UNITED STATES PATENT AND TRADEMARK OFFICE

APPLICATION NO.	FILING DATE	FIRST NAMED INVENTOR	ATTORNEY DOCKET NO.	CONFIRMATION NO.
10/762,467	01/23/2004	Makiko Mori	02910.000113.	5471
5514 7590 04/14/2011 FITZPATRICK CELLA HARPER & SCINTO 1290 Avenue of the Americas NEW YORK, NY 10104-3800				
EXAMINER				
STTA, GRANT				
ART UNIT		PAPER NUMBER		
2629				
MAIL DATE		DELIVERY MODE		
04/14/2011		PAPER

Office Action Summary**Application No.**

DETAILED ACTION

FIG.2

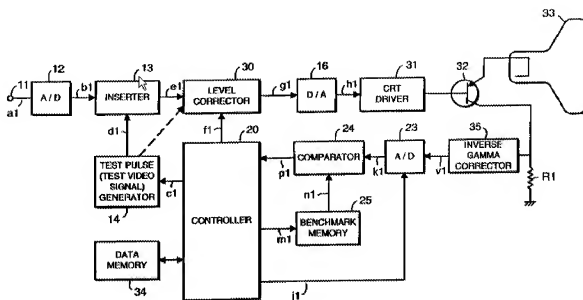
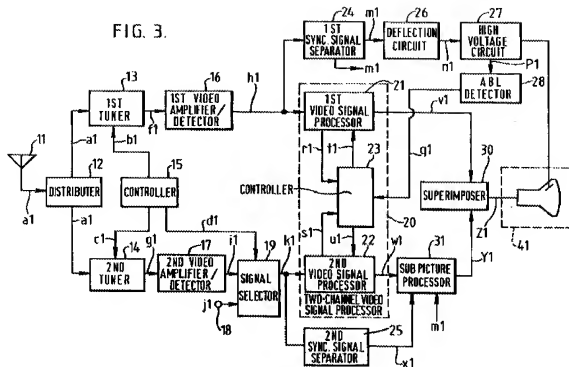
Tsuzuki teaches an automatic brightness correction apparatus for automatically correcting the brightness property of the image display device is configured to insert a test pulse at a predetermined level within a level range including an intermediate level to the video signal and displays the image of the test pulse on the video image display device, detect a deviation of the brightness of the image of the test pulse displayed on the video image display device from a benchmark, and correct the level of the video signal based on the detected deviation. While Tsuzuki teaches using a test pulse the claim language fails to preclude from using a test pulse. Examiner asserts the modification, Tsuzuki in view of Yamaguchi would allow wherein said display brightness feature value detecting circuit receives the superimposed video signal output from said

superimposing circuit and calculates, before the superimposed video signal is input to the display panel, the display brightness featured value from the superimposed video signal in which textual information or an icon is superimposed.

Yamaguchi teaches a superimposing circuit fig. 3 (30) shown below. The ABL Examiner notes, though the ABL is considered from the superimposed circuit corrections are made to the brightness for a 1st video signal independently fig. 4 (signal from g1 and (211)).

FIG.2

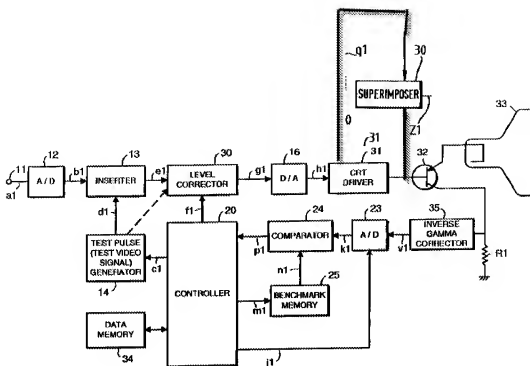
Examiner asserts it would have been obvious to one of ordinary skill to modify the brightness correction means of Tsuzuki, and insert the superimposing circuit (30) at the final stage of Tsuzuki, i.e., between (31 and 32 shown in fig. 2 see the proposed modified circuit below), in order to provide a means that does not limit brightness of one main picture element when compared with one sub picture element see col. 3, lines 40-67. Examiner notes, brightness detection is done in the final stage, see element (32), before the superimposed image is sent the display (33).
